PUBLIC WORKS/HYDROLOGY

RE: Heritage East Unit 4 - Drainage Report

HERITAGE EAST UNIT 4

REF: DRAINAGE REPORT FOR HERITAGE EAST UNIT 4 (D2O-D3B) RECEIVED MAY 8, 1985

OFF-SITE DRAINAGE
SCALE 1" = 500'

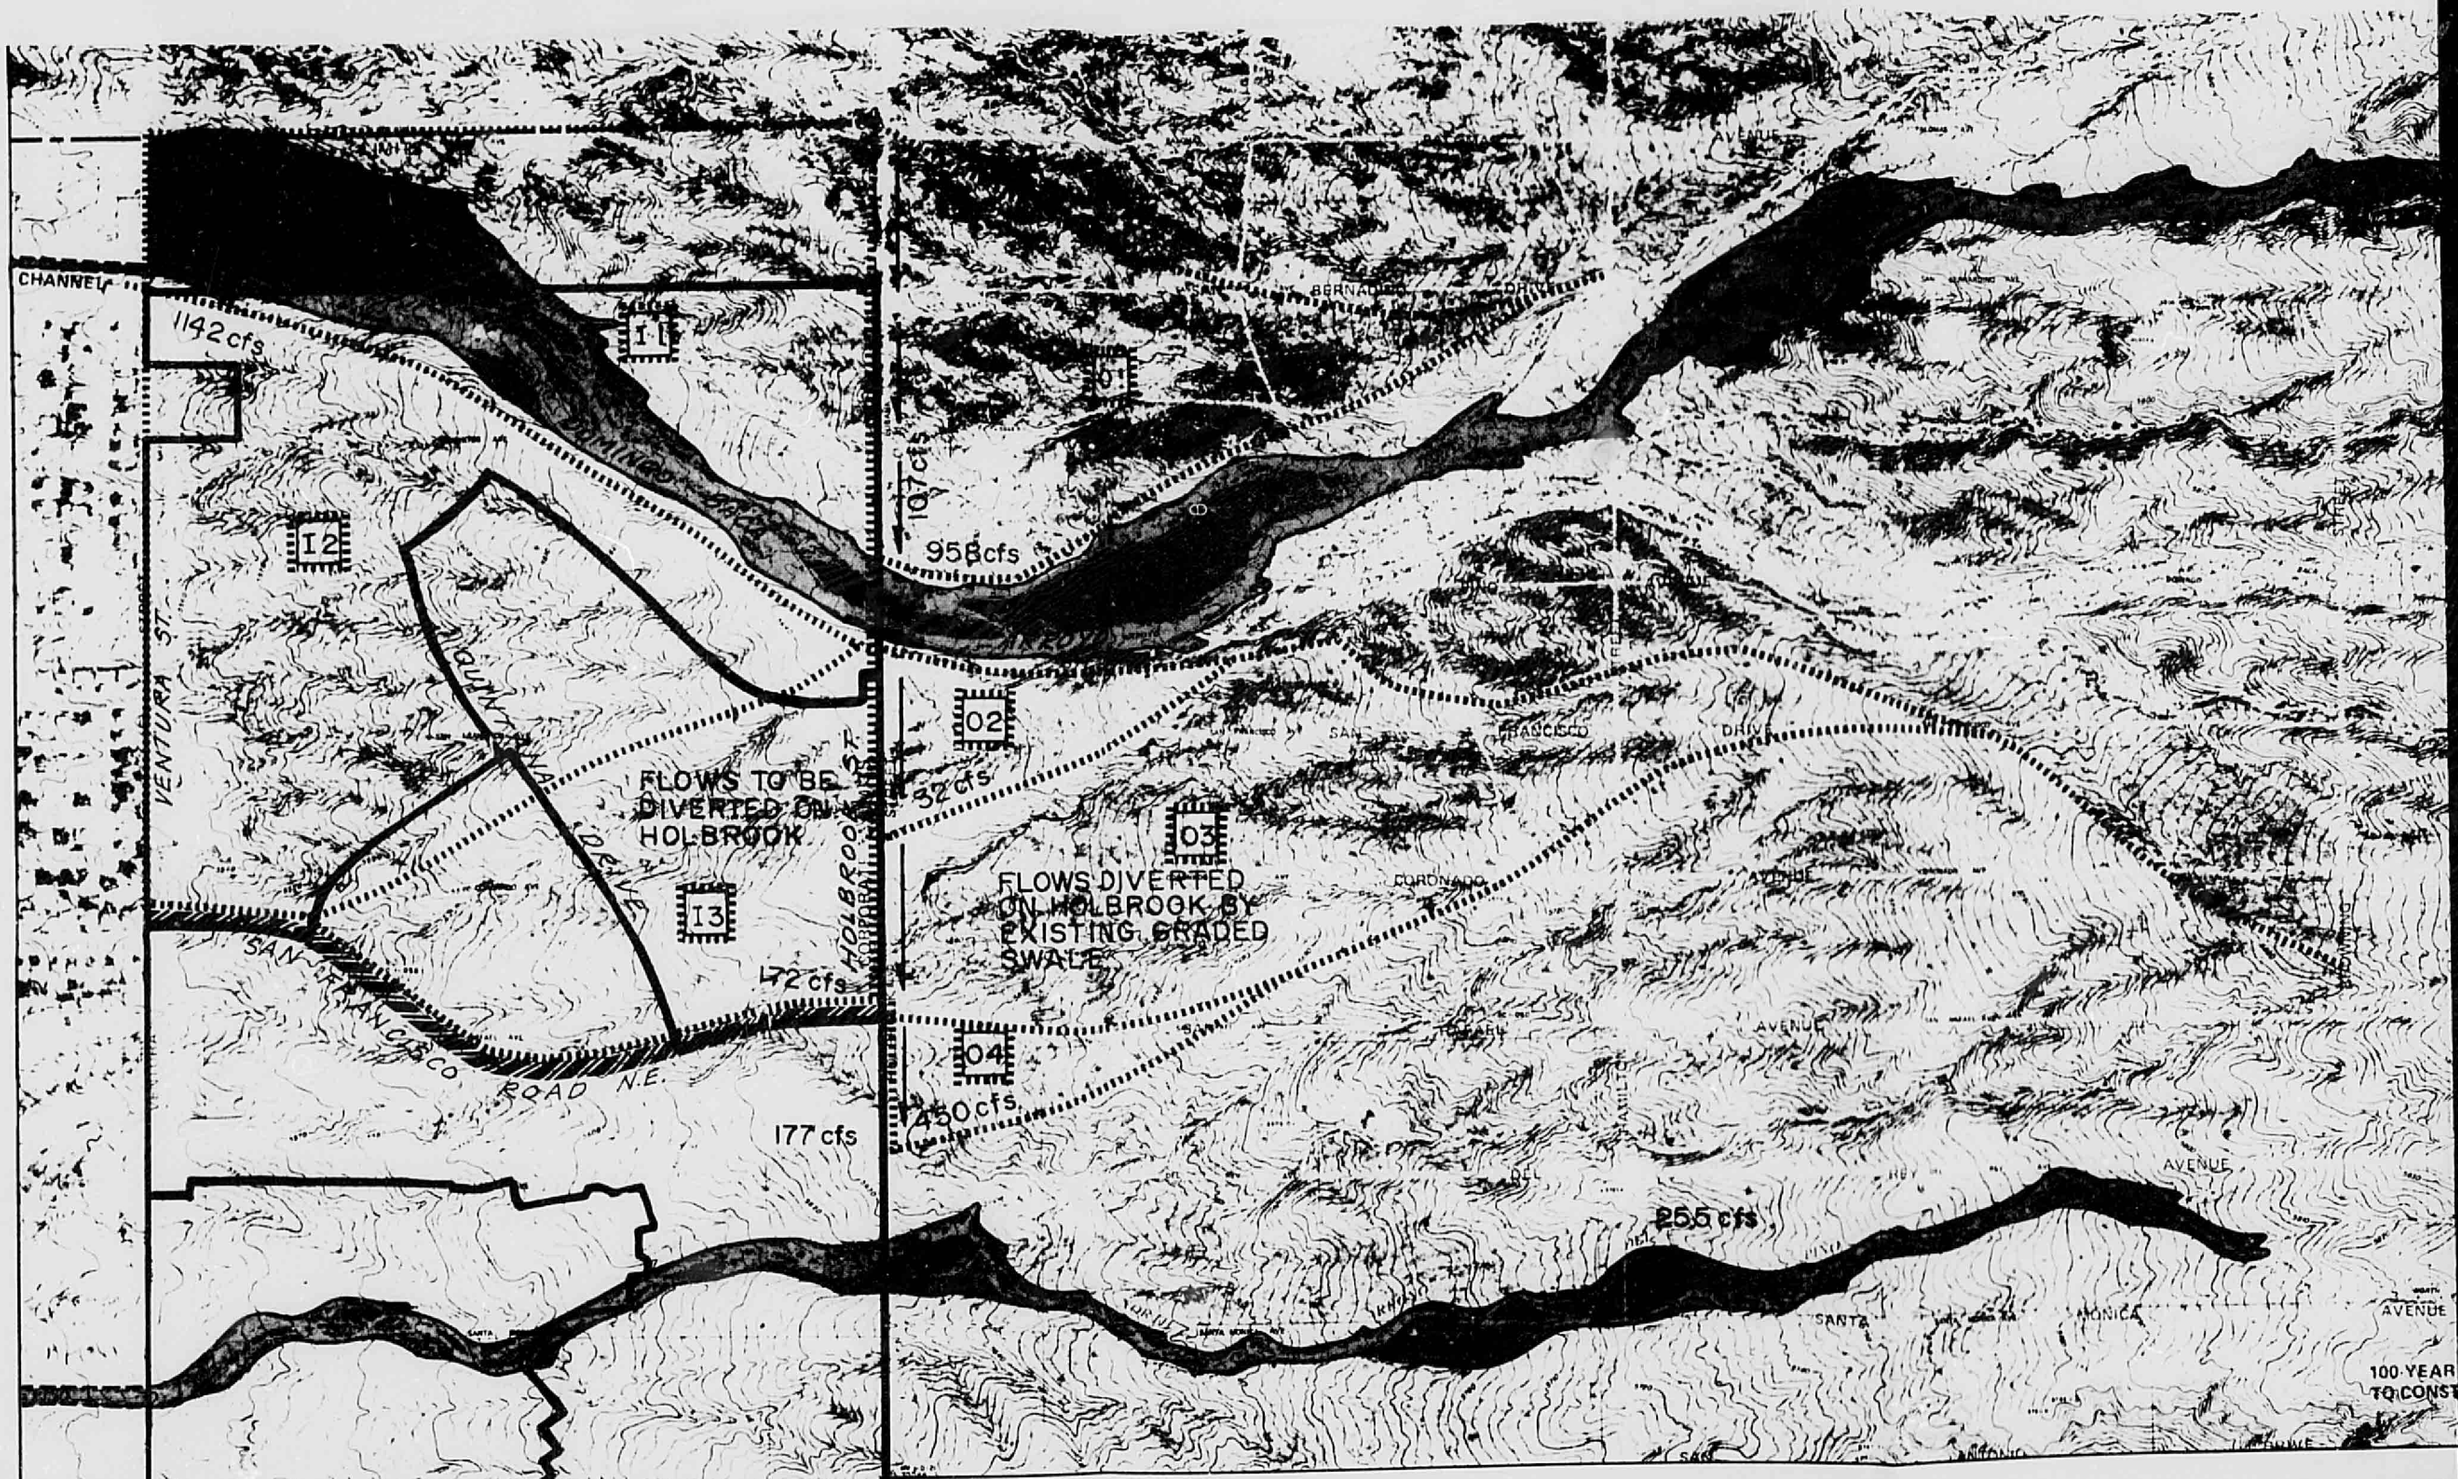
The most significant characteristic of the offsite drainage area is the Arroyo Domingo Baca. The historic flow of the arroyo has been modified by the construction of the South Domingo Baca Dam west of Lowell Street. Flows south of the Domingo Baca enter the site as shown on Plate I.

A. Channel flows (See Plate I)
